Quad Cities Nuclear Power Station, Units 1 and 2
Renewed Facility Operating License Nos. DPR-29 and DPR-30
NRC Docket Nos. 50-254 and 50-265

Subject: Response to Request for Additional Information Regarding Fukushima Lessons
Learned - Flood Hazard Reevaluation Report

Response to Request for Additional Information

Figure 1 - Image of the Quad Cities site, with an example of the unmodeled VBS openings shown. Additionally, an example of the ~3-4 ft openings can be seen in the top right portion of the zoomed image. (from the NRC's Request for Additional Information)

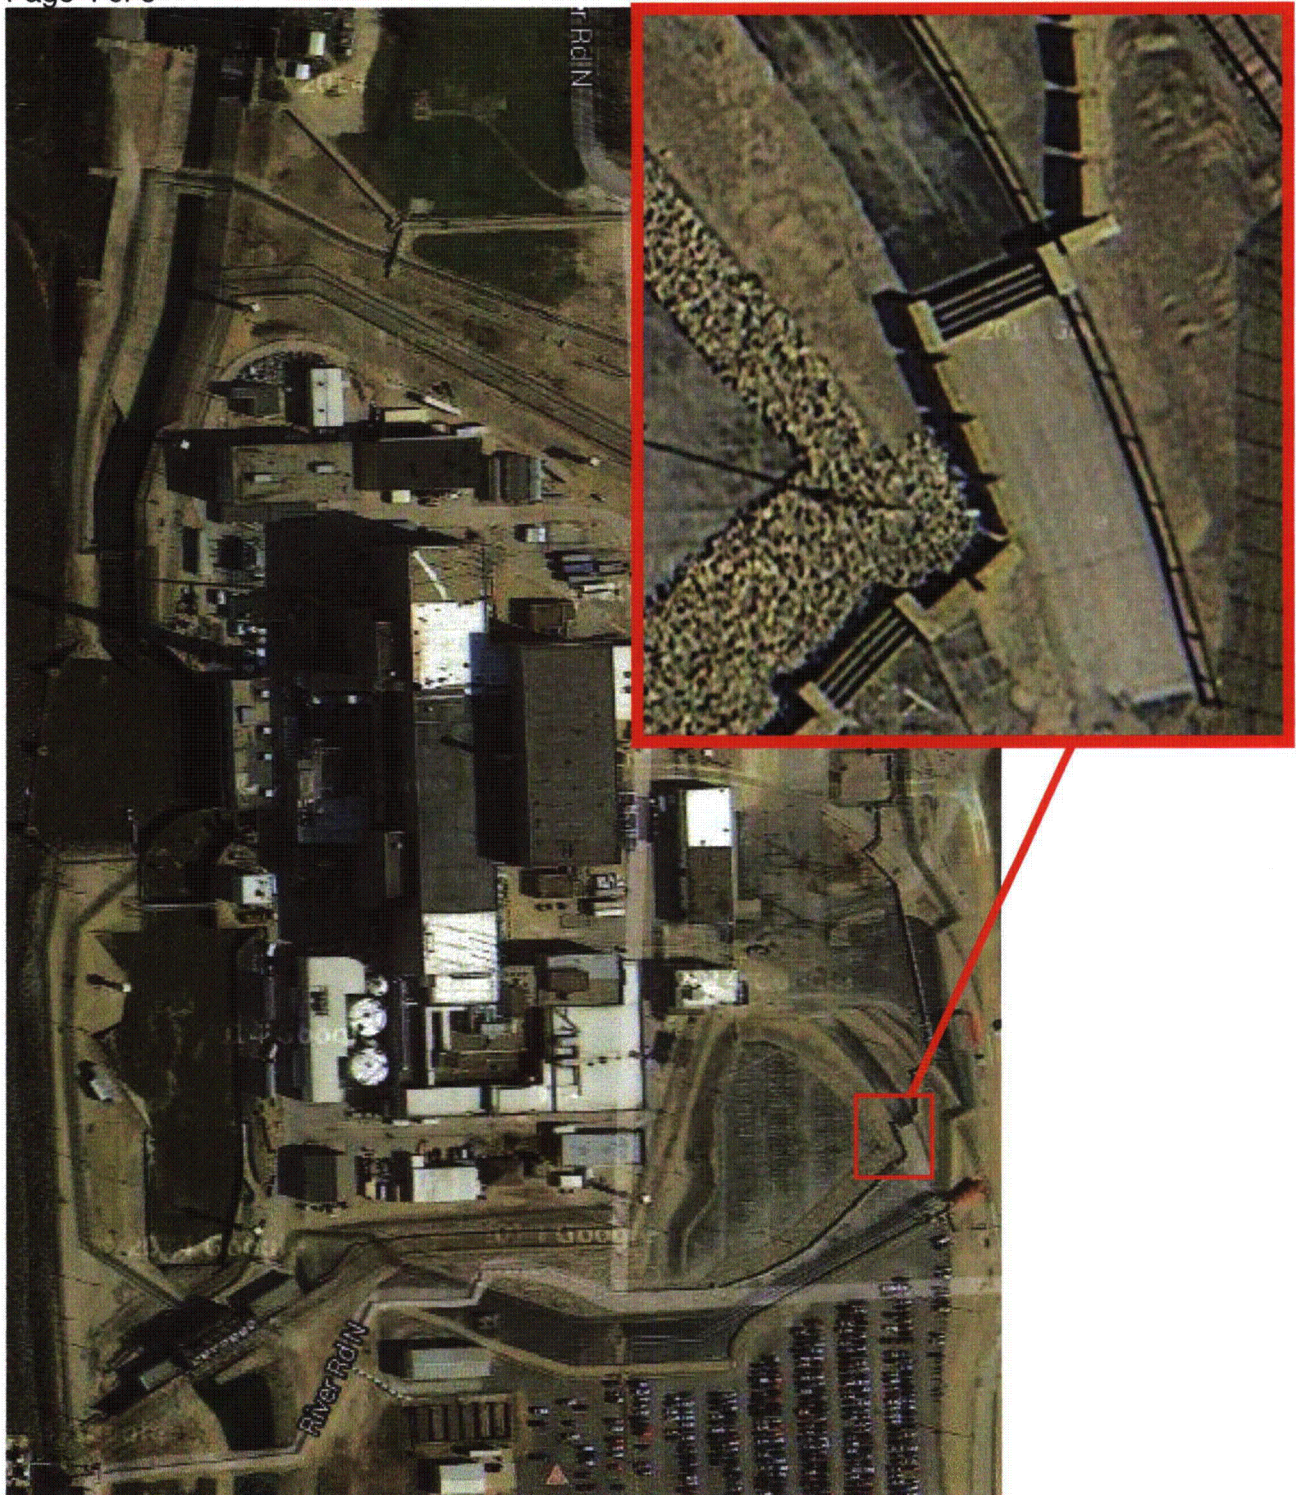
Background: In its RAI response, the licensee stated that “the use of the levee feature allowed for modeling of the gaps between the security barriers to accurately represent potential flow paths around and over the structures.” Figure 1 shows several openings in the VBS. However, the modeled levee feature does not appear to account for the numerous openings present along the VBS, especially along the East end of the site. Additionally, based on discussions with the licensee, the staff understood that the water does not discharge past the barriers until the water surface exceeds the barrier height at which point water overtops and flows over the barrier, but not around the barrier. Figure 1 shows multiple other VBS features that represent more sizeable openings that were not identified in the FLO-2D model. The lack of VBS openings could create an artificial backwater effect in the model, which could reduce the volume of water conveyed within the VBS and reduce maximum flow depths.

Request: The staff requests that the licensee quantify and account for discharge passing through the gaps in the VBS. The example gaps shown in Figure 1 are representative of similar gaps in other sections of the VBS. The staff also requests that the licensee analyze the effect of water flowing through these gaps in the numerical model. These gaps are denoted in green, adjacent to the red VBS, in Figure 2. The licensee response should describe effects associated with discharge passing through the larger, vehicle-sized, gates and the smaller 3-4 foot gaps in the VBS.

The FLO-2D model was revised to enhance representation of flow through openings in the Vehicle Barrier System (VBS), particularly on the east side of the plant. Field measurements indicate that the width of the openings in the VBS vary between 1 foot and 2 feet each. Due to the size of the grid elements (set at 20 feet by 20 feet to provide sufficient detail while maintaining reasonable computational time), openings in the VBS were represented by creating 20-foot openings to conservatively represent the cumulative effects of multiple 2-foot openings. The openings in the FLO-2D levee feature were placed toward the low point in the FLO-2D grid surface to maximize the cumulative flow at these locations. The ratio of the total number of actual 1 to 2-foot openings to the total number of representative 20-foot openings in the model is just under 5. That is, on average, each 20-foot opening in the model is conservatively representing less than 10 feet of actual openings along the VBS. The FLO-2D model also includes individual openings in the levee feature at personal and vehicle gates. Figure A-15 of Reference 1 shows the locations of representative and individual openings in the FLO-2D levee feature.

The model is intended to accurately characterize conditions near plant structures during a LIP flood. However, the model configuration for the VBS is conservative because the 20-foot openings in the FLO-2D levee feature pass flow at a higher rate than in reality, decreasing storage and attenuation on the east side of the VBS.

Figure 2 - FLO-2D model including VBS. Blue arrows indicate locations of VBS openings that were identified (from the NRC's Request for Additional Information)

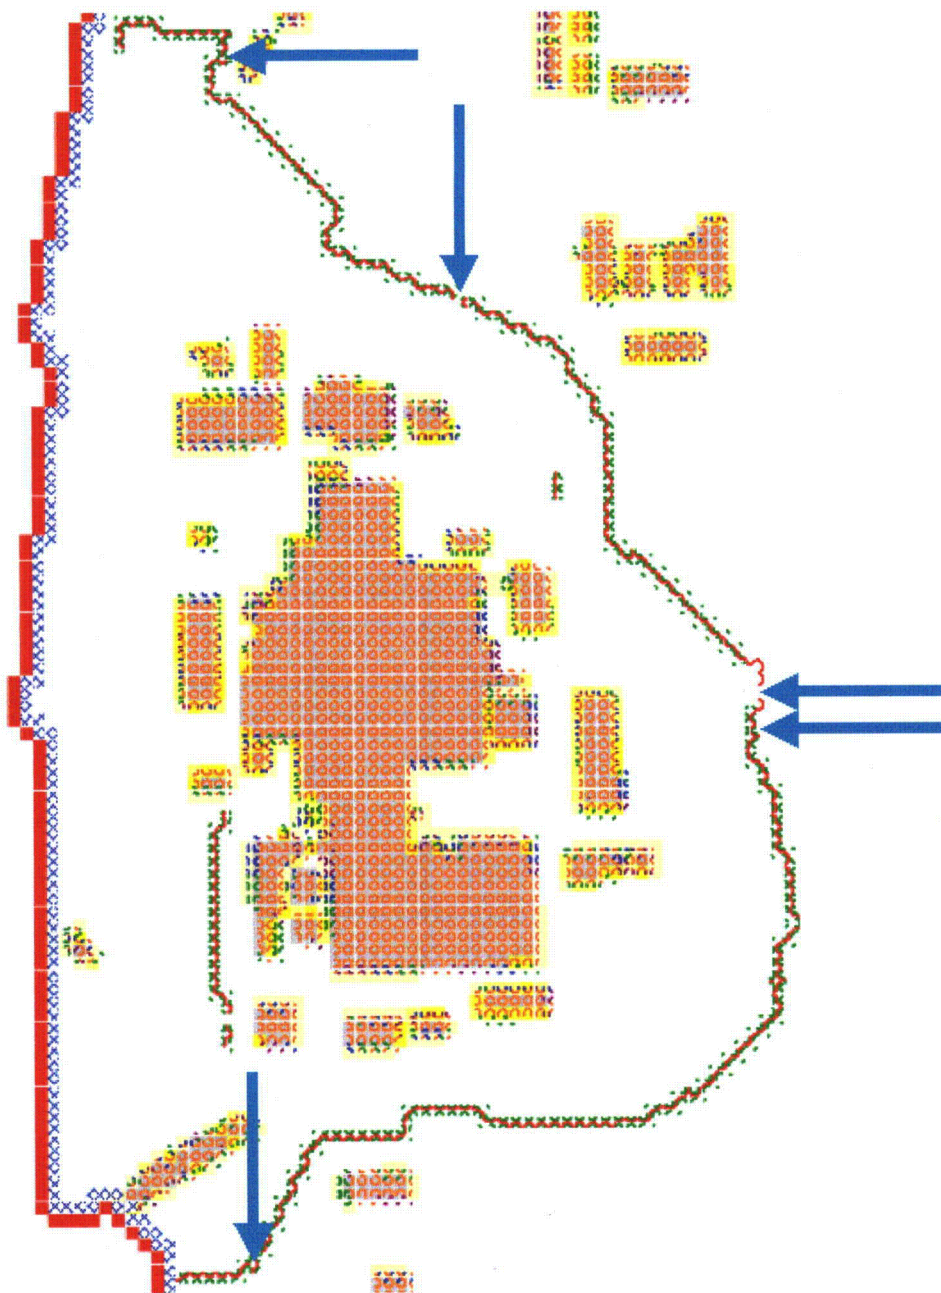
Additionally, staff identified width reduction factors (WRFs) of 0.1914, which were included along the FLO-2D levees (see the green lines surrounding the red levee lines in Figure 2). Based on discussions with licensee, the staff understood that the WRFs are used to account for the actual length of the barrier, as the modeled length within the cells is larger than the actual barrier. However, there is no mechanism to account for flow in the gap areas (~3-4 ft. openings in Figure 1) between the barriers.
